# 1997 - 1998 Corvette: Service Bulletin: Discoloration or Staining of Plenum (Cowl) Air Inlet Screen

**Subject:** Discoloration or Staining of Plenum (Cowl) Air Inlet Screen

**Number:** 83-15-11

**Models:** 1997-1998 Chevrolet Corvette

**Figure 1**

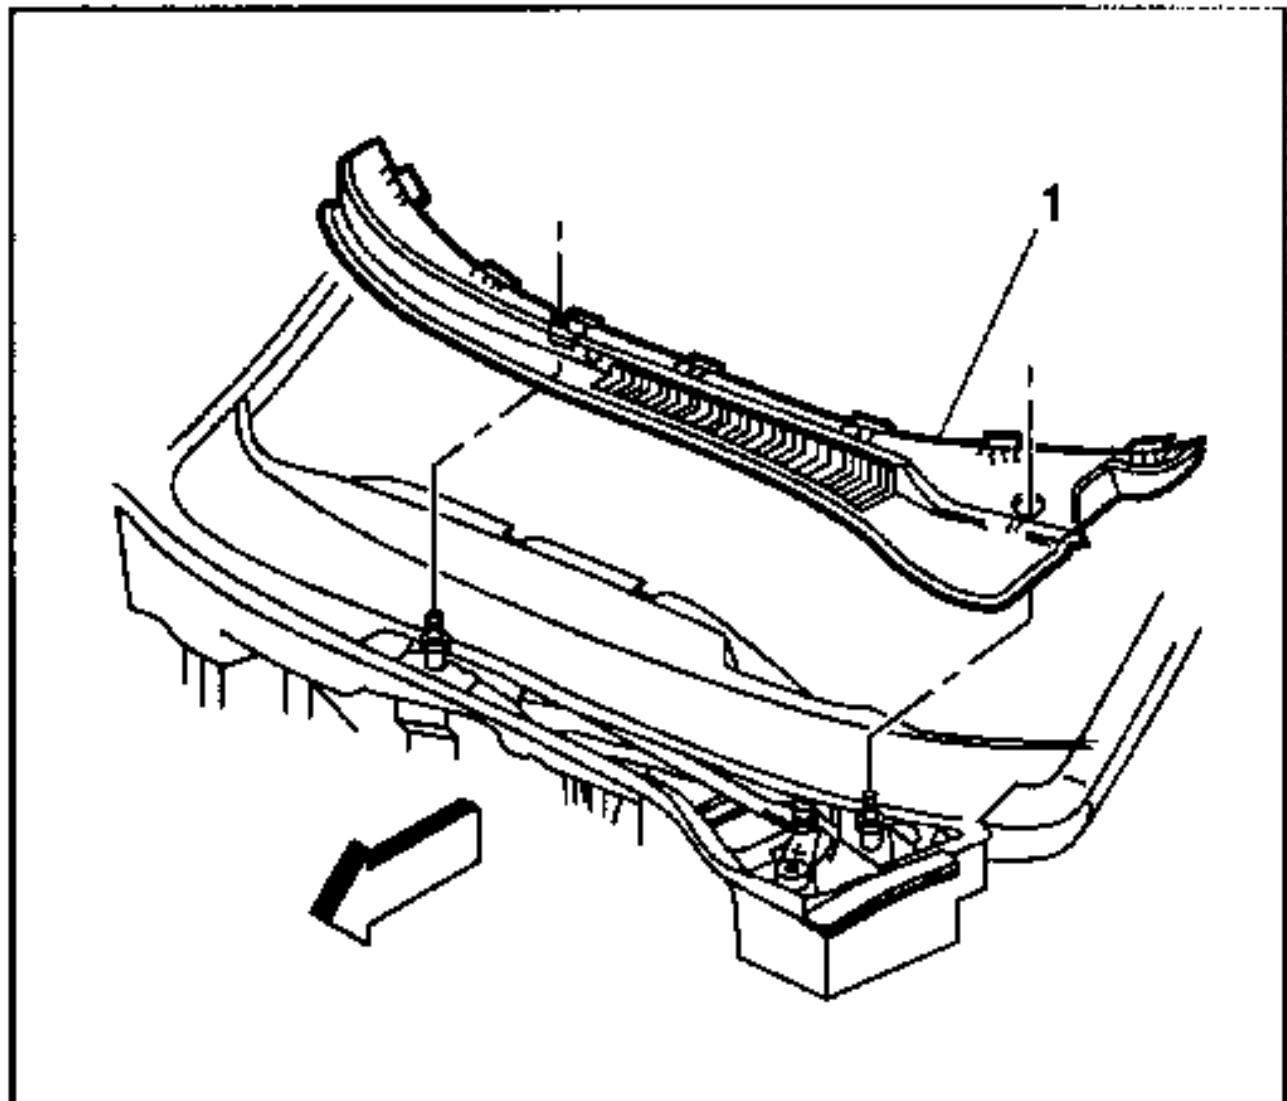
**Condition:** SOME CUSTOMERS MAY COMMENT THAT THERE ARE WHITISH SPOTS OR STAINS ON THE PLENUM AIR INLET SCREEN AT THE BASE OF THE WINDSHIELD. THESE SPOTS OR STAINS ARE USUALLY FOUND IN THE AREAS AROUND AND BELOW THE WINDSHIELD WIPER ARMS AND BLADES.

THIS CONDITION MAY BE CAUSED BY A CHEMICAL RESIDUE USED IN THE MANUFACTURING PROCESS OF THE WINDSHIELD WIPER WASHER NOZZLES. RESIDUE IS WASHED OUT FROM INSIDE THE NOZZLES DURING THE FIRST FEW USAGES OF THE WINDSHIELD WIPER WASHERS.

INSTALL NEW AIR INLET SCREEN (P/N 10418245), USING THE PROCEDURES IN THE APPROPRIATE SERVICE MANUAL
